RE: Del Monte Warehouse windows

Del Monte Cannery

Proposed Window Replacements

Topic Proposed Roof Monitor

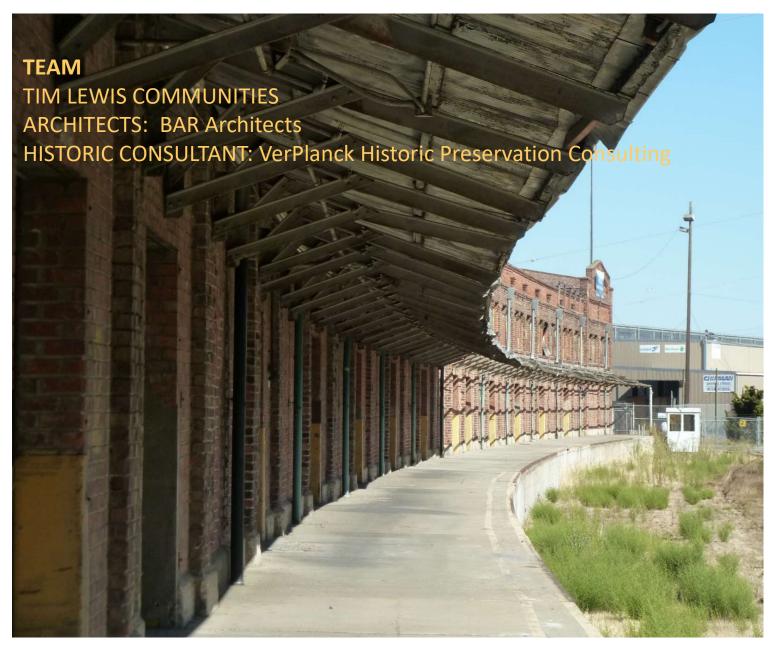
In my opinion, the windows selected by Tim Lewis Communities, the Graham Architectural Products SR6700 series window, will comply with the Secretary of the Interior's Standards. As explained to me by Mr. O'Hara, Graham has been directed to develop a replacement window that matches the originals in terms of overall dimensions, lite configuration (18 lites per window) with narrow muntins measuring 1-1/8" wide. Although the operable panels at the center of the windows do not appear to be historic features of the original windows, operable panels are certainly common with this building type and era of construction. The incorporation of egress panels on the monitor windows is also not a feature of the original windows, but I do not think they will be all that noticeable given that they would remain closed

most of the time, the receding angle of perspective, and the distance from Buena Vista Avenue and other nearby streets.

Replacement Window

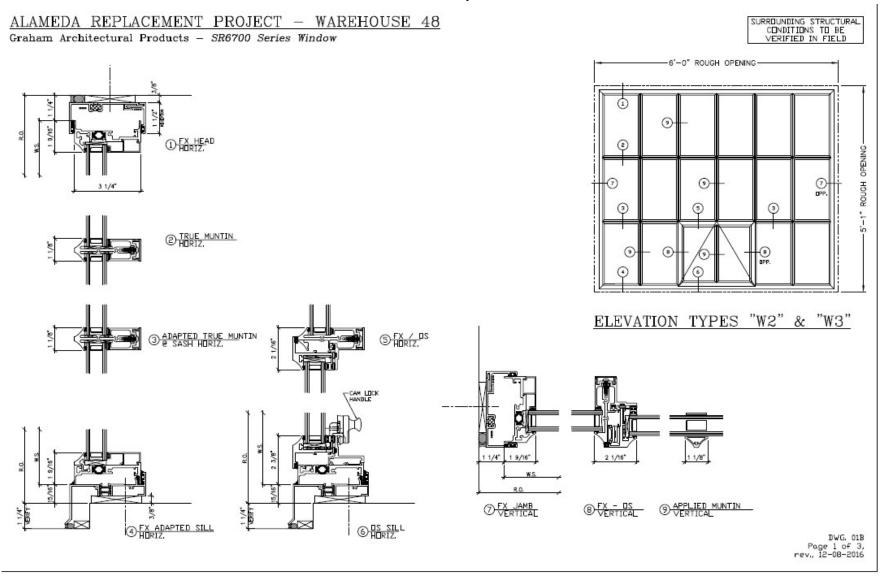
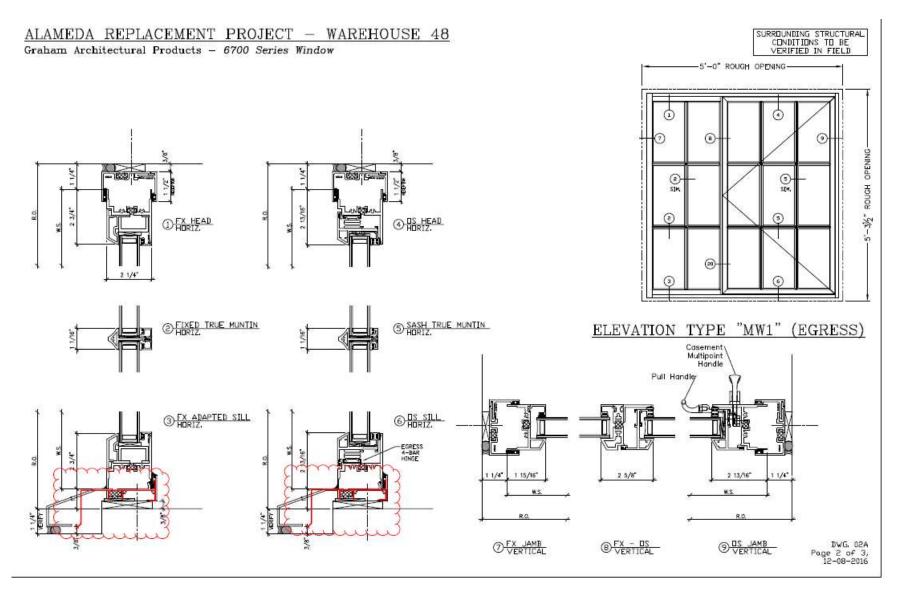
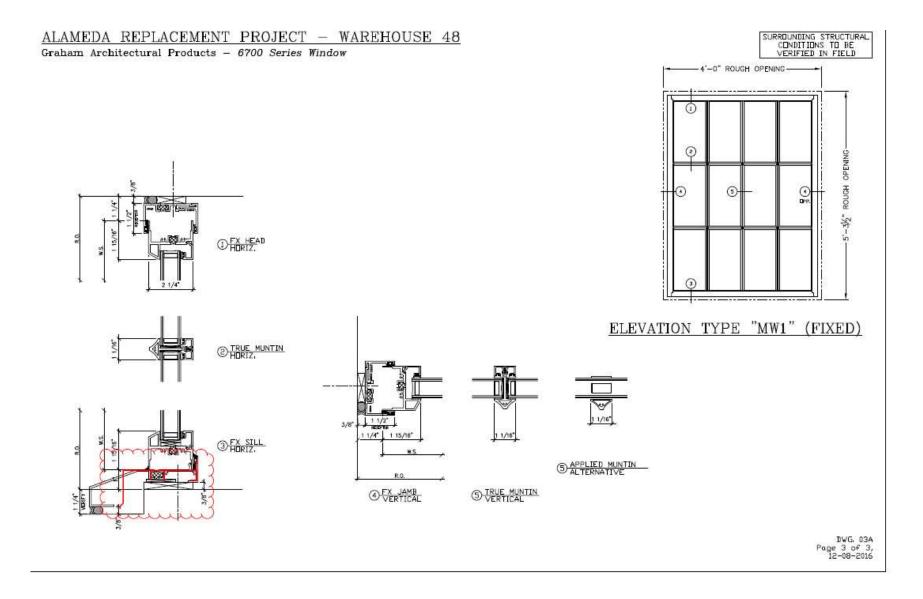
We have proposed a replacement window manufactured by Graham, a company that specializes in replacing historic building windows. They have a successful track record on National Park Preservation projects. The replacement windows themselves, including the mullion patterns, were designed to replicate the existing windows in a manner that is consistently compatible with the historic character of the industrial qualities of Del Monte Warehouse. Both the flats and monitor will be operable allowing for code compliance in a historic manner. Please also reference the memorandum written by Christopher VerPlanck on 2/22/17.

Development Plan Concept: The Sky Canopy in Bays 1 and 4

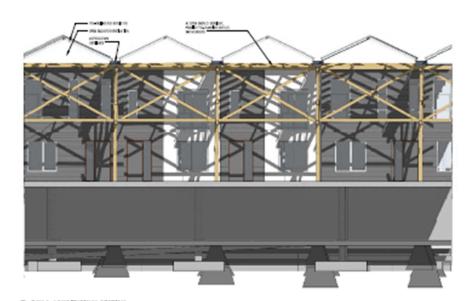
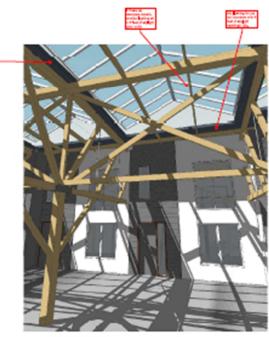
As you know, I was involved with the design and the entitlements process for the adaptive reuse of the former Del Monte Cannery property in Alameda. Mike O'Hara of Tim Lewis Communities asked me to review three options for the proposed roof monitor on the building – an entirely new feature. Assuming that you have seen the options, 1, 2, or 3 appear to be mutually acceptable and none would alter my conclusion regarding the project's compliance with the Secretary of the Interior's Standards.
